Date: 12/15/96

The SPI-2 editing session made the following recommendations:

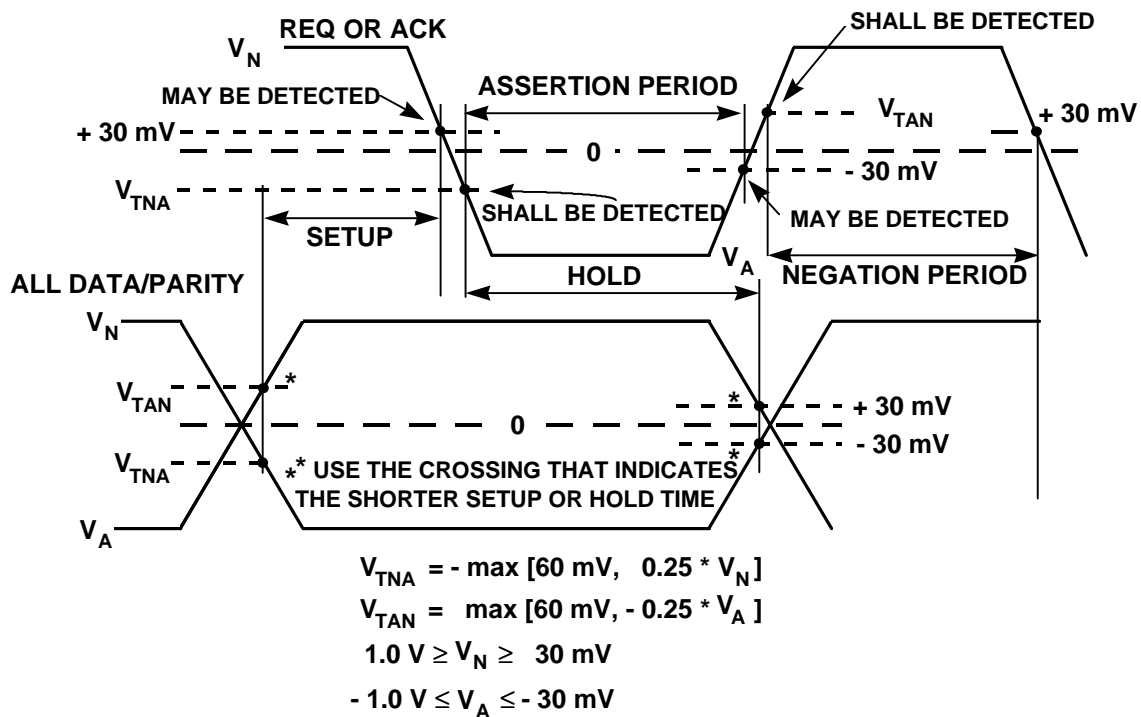
Figure 24 - LVD has no hysteresis; need to add may be detected and shall be detected to fig 24 and change to 30 mv. See revised figure
